## SCH3227/SCH3226/SCH3224/SCH3222 Silicon Errata and Data Sheet Clarifications

**Note:** The following typographic corrections and clarifications apply to Data Sheet Document #00002121A, which is at Revision A, and specifies only the family members SCH3222, SCH3224, SCH3226 and SCH3227. Other members of the SCH322x family have separate data sheets, and separate errata sheets.

### 1. Module: Serial Port

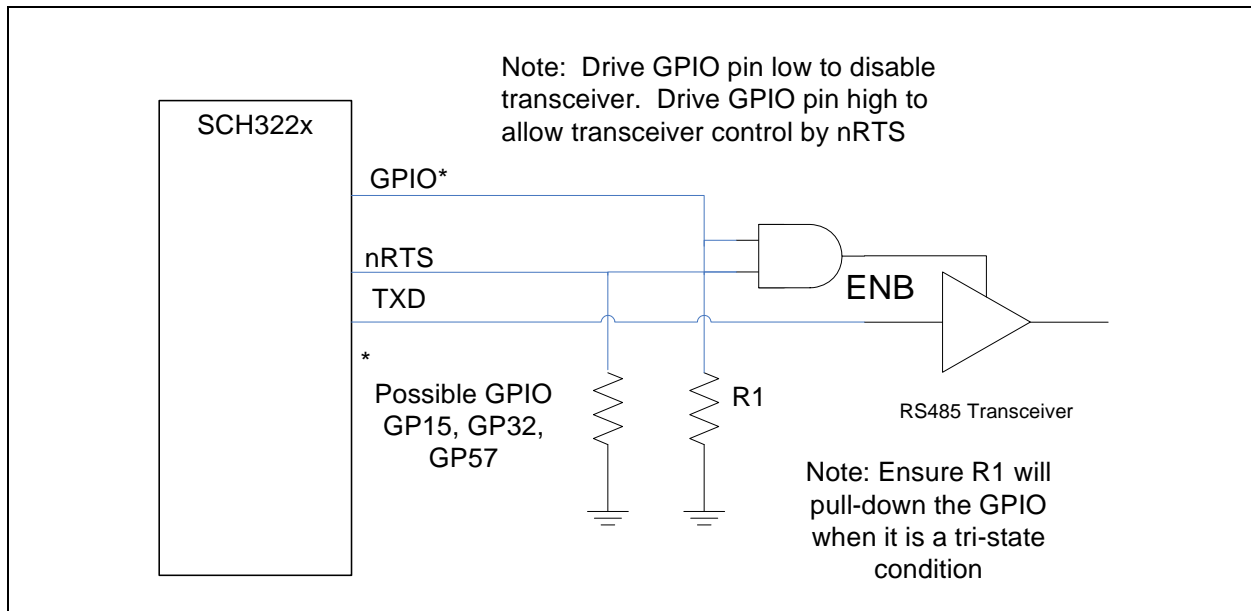
UART 3 and UART 4 do not tri-state their outputs on a PCI\_RESET as do UART 1 and UART 2.

UART 3 and UART 4 outputs are not controlled by the Configuration Register 0x30 ACTIVATE bit.

UART 3 and UART 4 outputs will drive High when PCI\_RESET goes active or when the ACTIVATE bit is cleared, and if the platform uses RTS to control an RS485 transceiver this may interrupt communication.

Use GPIO pin to disable RS485 transceiver when ACTIVATE bit is cleared.
